SUBJECT: RESPONSE TO THE NOTICE OF DISAPPROVAL FOR THE PUEBLO CANYON AGGREGATE AREA INVESTIGATION WORK PLAN DATED JULY 26, 2005

**Response to the Notice of Disapproval for the
Pueblo Canyon Aggregate Area Investigation Work Plan
Dated July 26, 2005**

**Response to the Notice of Disapproval for the
Pueblo Canyon Aggregate Area Investigation Work Plan
Dated July 26, 2005
Los Alamos National Laboratory EPA ID No: NM0890010515
HWB-LANL-03-007**

Figure 2.15-8. Consolidated Unit 45-01-00 historical sampling locations [excluding Consolidated Unit 01-002(b)-00] with organic chemicals detected

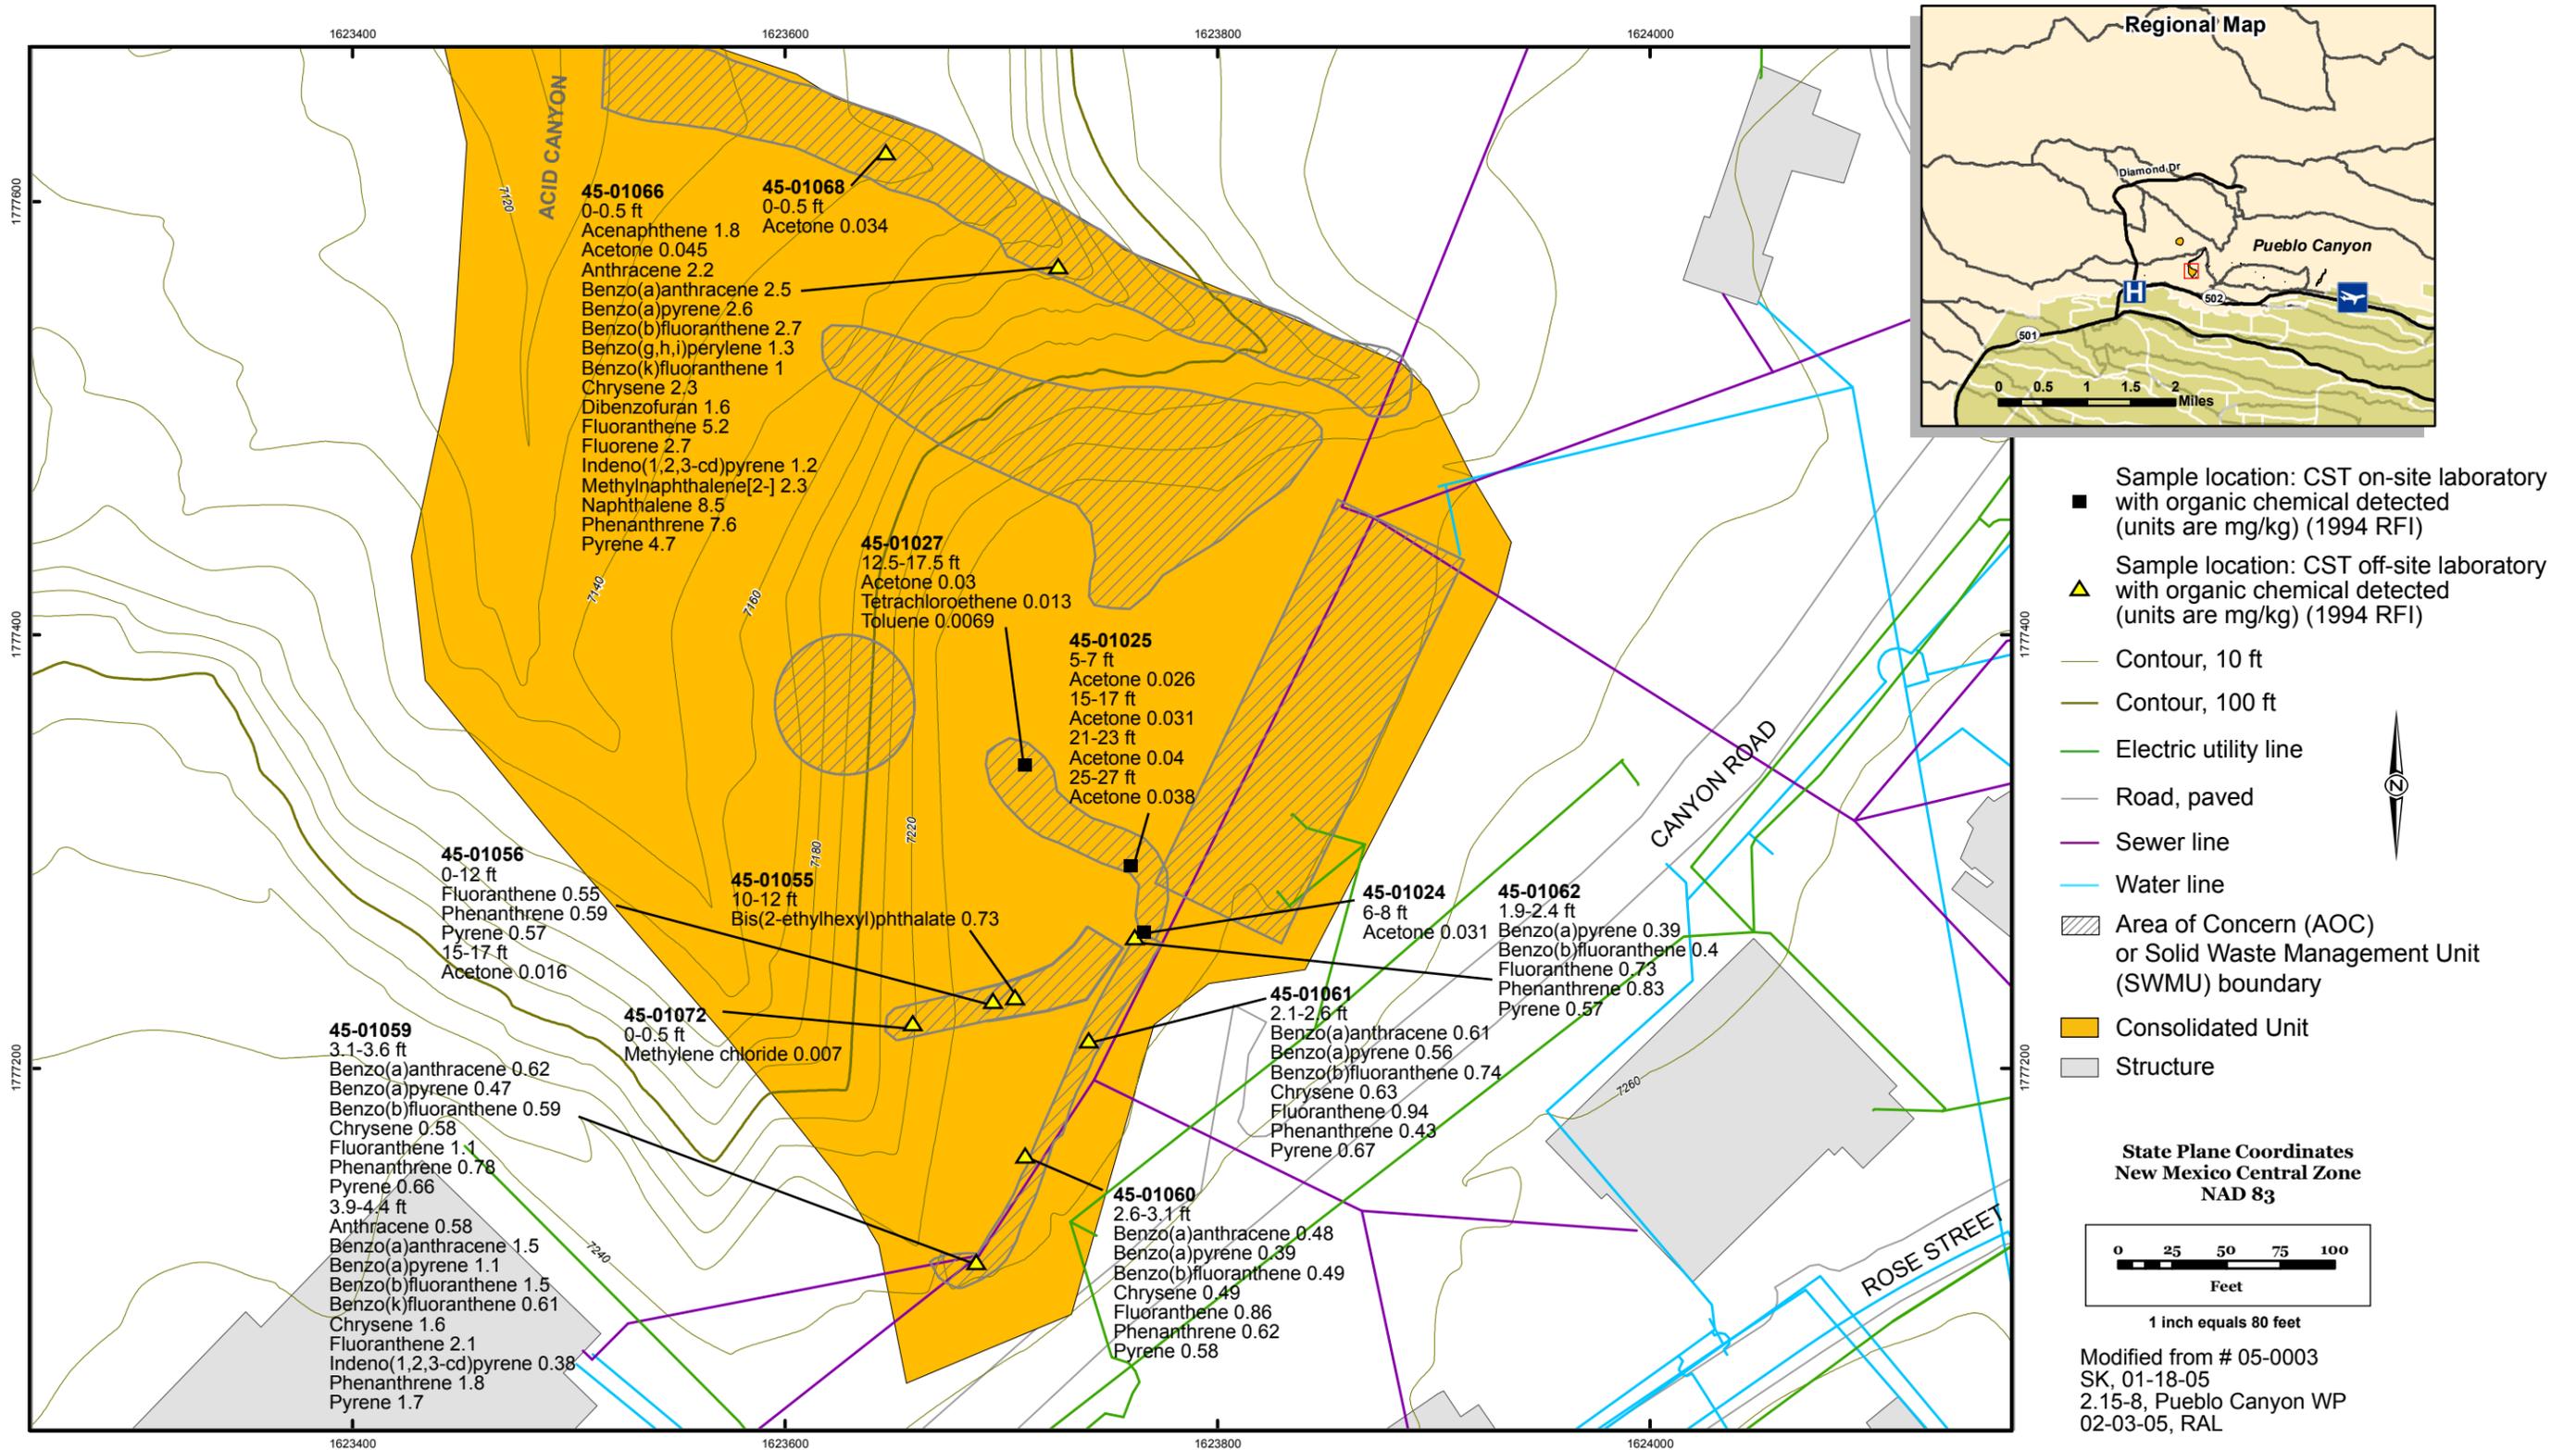
- e. *Sanitary Sewer Emergency Bypass (SWMU 45-004): The Permittees must provide the data for location 45-01068 and justify resampling at the same depths at this location.*

The historical data for samples from location 45-01068 are provided in the work plan in Table C-1.0-12 (off-site analyses of VOCs and SVOCs only) and in Figure 2.15-8 (Attachment 3 to this response).
